# Applicant Response

Application Review Summary REZ No. 00746 & DPV No. 00155 December 3, 2020

**TELUS** ocean

Elevation Illustration: Looking East

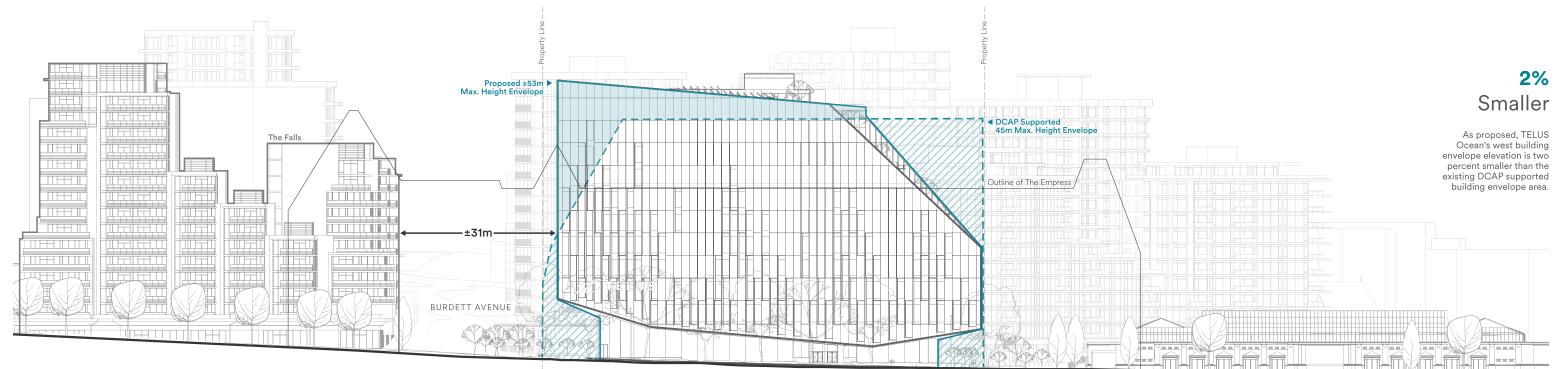
1A "The density distribution to provide significant building separation to the adjacent residential building is positively noted, however, the overall density results in a significantly long and unbroken building length along Douglas Street and a building height that exceeds what is envisioned for the area. Given the critical and iconic views outlined in the design guidelines for the Inner Harbour, it is difficult to support a height variance for the length of building in excess of the maximum height at this location. Design revisions to reduce the amount of massing that exceeds the maximum building height and to break up the perceived length of building along Douglas Street are required. The building separation to the adjacent residential building should be maintained with these revisions, which will likely result in a reduced overall density."

The greatest mass, building width and gross square footage have been located toward the south — the widest and most developable portions of the site. The highest portion of the building has been oriented toward the most northern portion of the site where both the tallest buildings and most generous building separation distances exist. The building design descends in part toward the south where the lowest neighbouring building heights exist.

At its closest point, TELUS Ocean is over 30m away from The Falls to the north and is separated by two public road right of ways — Burdett Avenue and Humboldt Street.

The Douglas Street streetscape illustrates the downtown skyline and relationship to the Empress roofline:

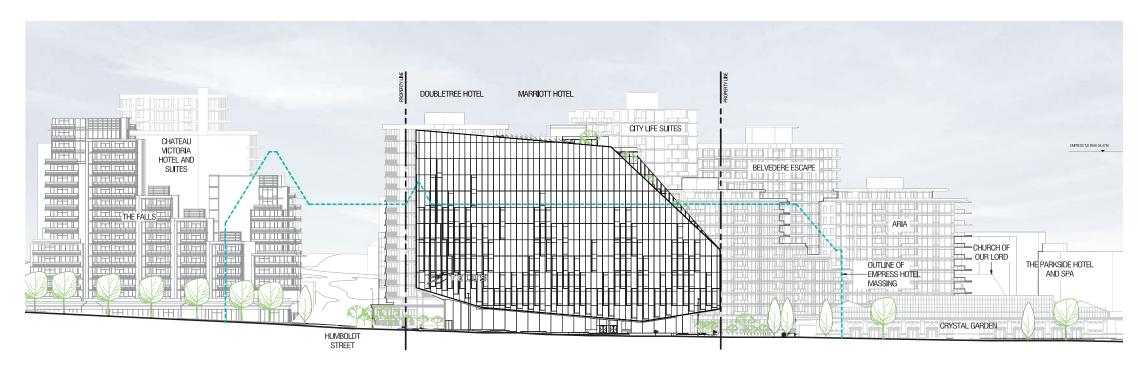
1B "To reduce the perceived scale and length of building along Douglas St. please consider introducing a building recess, shifts in building plane, or other architectural design approaches to break up the length of building while still maintaining a cohesive overall architectural composition."

- The facade pattern is revised to reference the scale and pattern of the Falls.
- The facade pattern is intentionally developed more at lower elevations to provide more interest at the street level; and less at upper elevations to act as a clean backdrop to the roofline of the Empress.

Section diagram showing solar shades

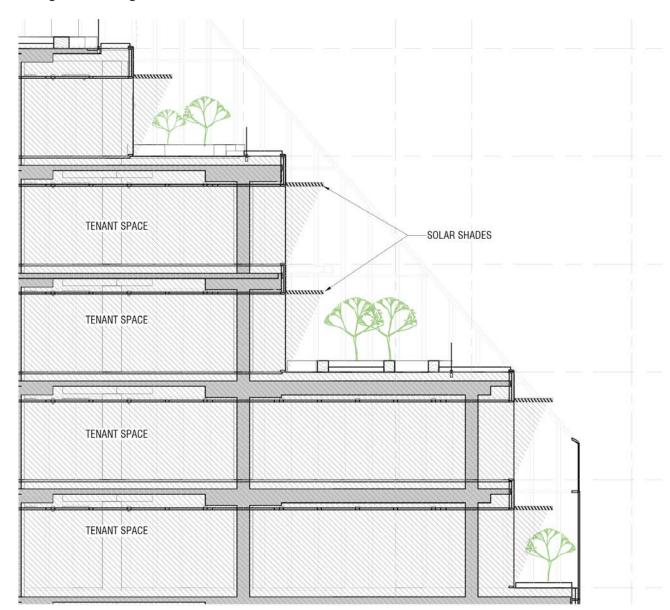
"The reflective and transparent glazed design intent is noted, however, Staff have a variety of concerns with this approach. The City of Victoria has declared a climate emergency, and glass clad buildings notoriously perform poorly in terms of energy efficiency, user comfort, bird collisions and often symbolize a lack of sustainability. This is particularly true for a predominantly west facing building. Furthermore, the existing form and character of the area is transitional and disparate. As such, instead of introducing a highly juxtaposed building and yet another contrasting design into this milieu, a more harmonizing architectural approach and energy efficient wall to window ratio is required to meet form and character policy objectives. This includes reconsidering the extent of glazing, a higher wall to window ratio and/or introduction of screens or some form of solar shading."

The updated window-to-wall ratio is **48:52.**To address glare and heat gain concerns, solar shading devices and plantings have been added along south-facing glazing on the terraces, improving occupant comfort and reducing cooling demand during the summer. Horizontal metal louvres shade nearly the full height of the south facing glazed units.

Twilight photomontage showing absense of artifical facade illumination above the Empress roofline.

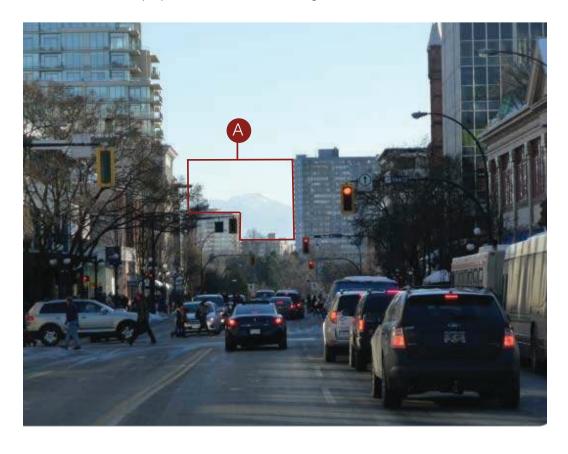
3B "Please provide an additional evening rendering from the Laurel point view point to illustrate how the application provides a sensitive and appropriate illumination of the building facade and architectural features to complement the night time views of the harbour without detracting from the lighting prominence of the Empress Hotel."

Most of the lighting will be located in the areas well below the roofline of the Empress hotel and will not detract from the architectural lighting of the Empress, the Victoria Conference Centre, and the Crystal Gardens.

The lighting, integrated into the returns of the angled panels, is intended to 'glow' or 'shimmer' - a subdued approach.

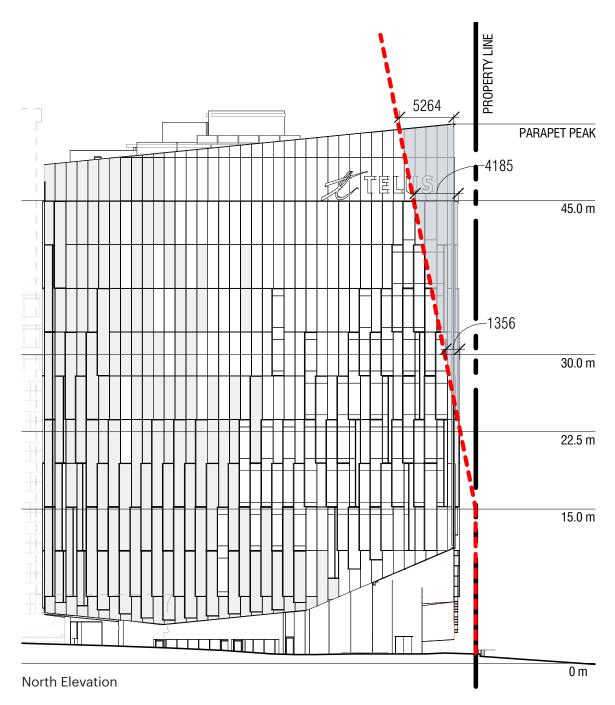
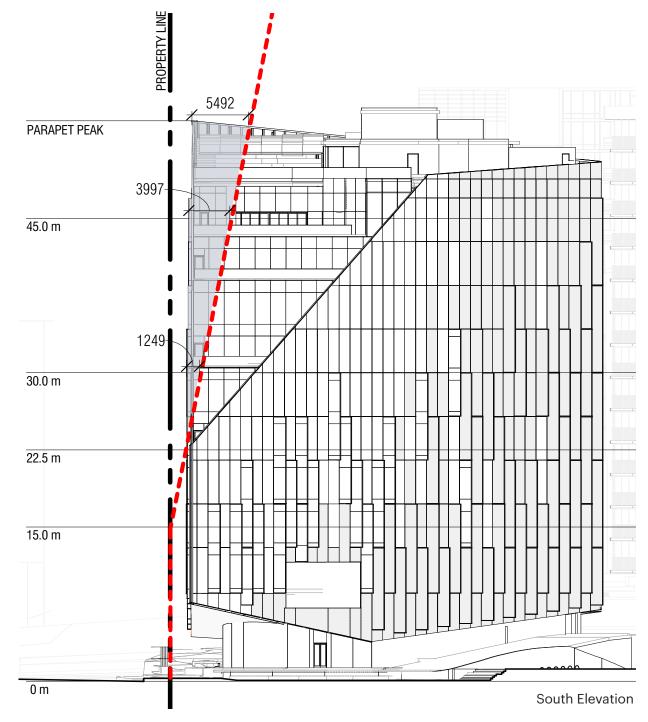
3E "On the north building elevation, please indicate where the 1:5 step back ratio above 15m from Douglas St. would land per DCAP policy 6.184.6 and dimension the infringement into the step back"

Acknowledged. Please refer to the elevations below for indication of 1:5 step back ratio from Douglas St.

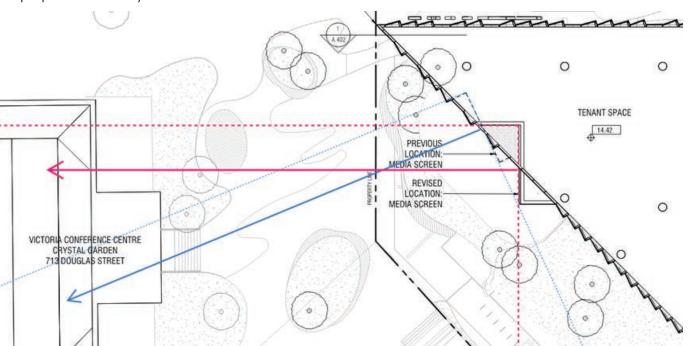
3G "Signage above the ground level is not supported at this location, within a landmark heritage radius. Please revise with the subsequent submission"

Signage has been lowered to ensure that it is not visible over the Empress.

Plan delineating scope of offsite works and landscaping

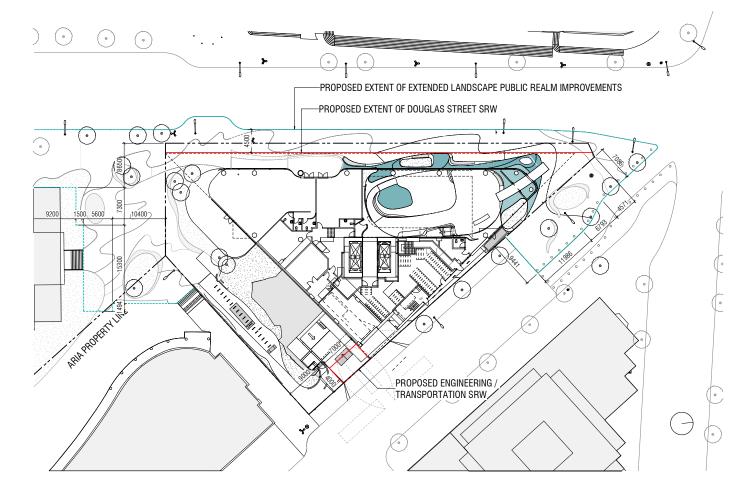
4B "A legal agreement is required to secure the off site works and landscaping proposed."

Plan delineating potential extent of scope of offsite works and landscaping as well as SRW's is below.

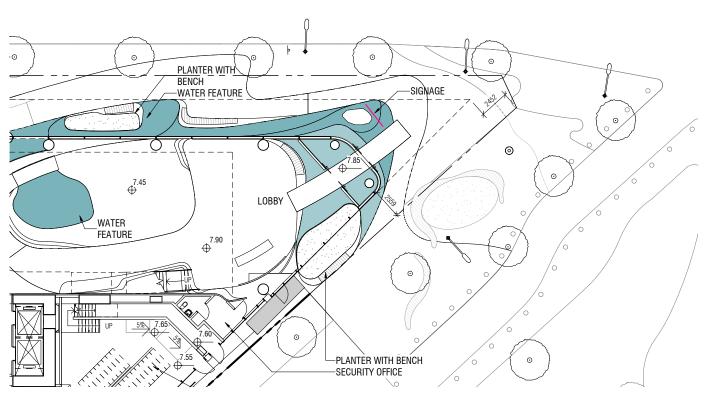
19 "Corporate signage is not supported or permitted on the public right of way. Please remove"

# Signage has been relocated onto the property.
